ORDINANCE NUMBER 2016-09

AN ORDINANCE OF THE TOWN OF PARADISE VALLEY,
ARIZONA AMENDING THE PARADISE VALLEY ZONING
ORDINANCE, Article XXII, HILLSIDE DEVELOPMENT
REGULATIONS

Section 1. Article XXII, Hillside Development Regulations, Section 2200- 2209 are hereby amended (with deletions shown as ~~striketroughs~~ and additions shown in **bold type**):

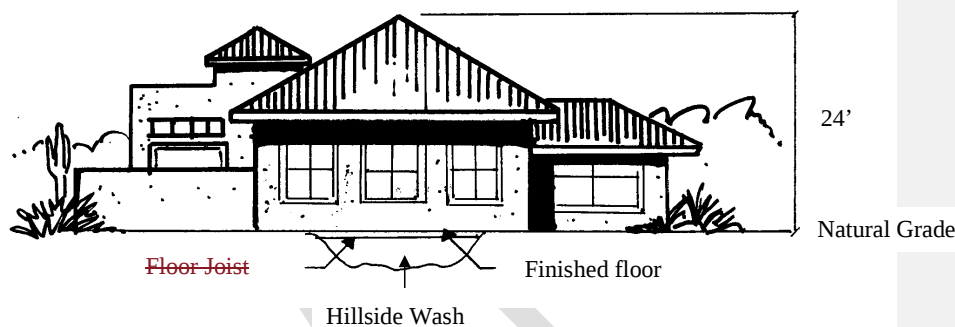
I CAN'T EDIT FIGURE 6. DELETE "FLOOR JOIST". IT ADDS NOTHING AND MOST LIKELY THE FLOOR WILL BE CONCRETE SLAB OR THE JOIST WILL BE COVERED WITH INSULATION AND NOT VISIBLE

Commented [PL4]: Remove floor joist arrow from staff version

FIGURE 7 - HEIGHT FOR A CANTILEVERED ELEMENT

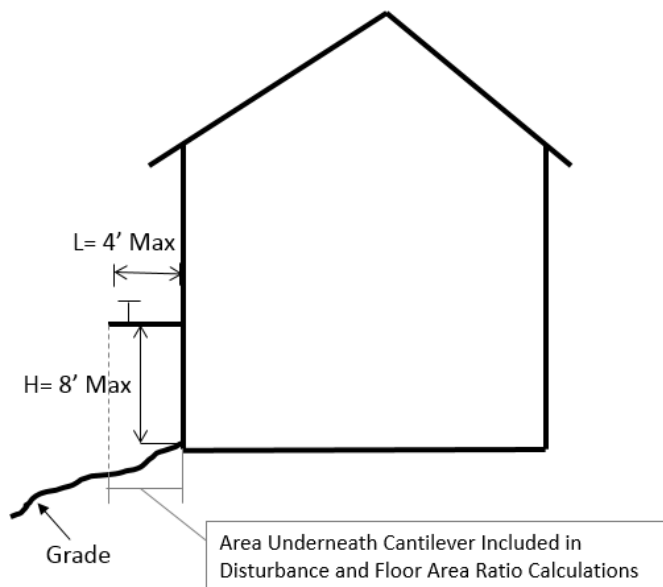
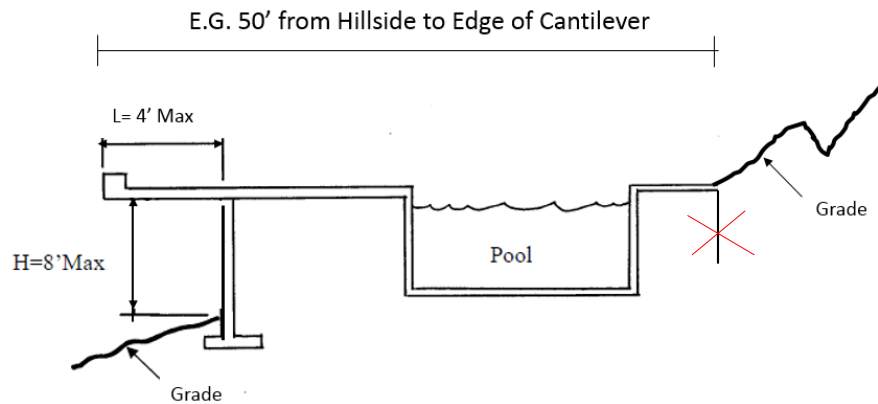
DELETE THE VERTICAL LINE ON THE RIGHT SIDE OF THE FIGURE. DON'T KNOW WHAT IT MEANS
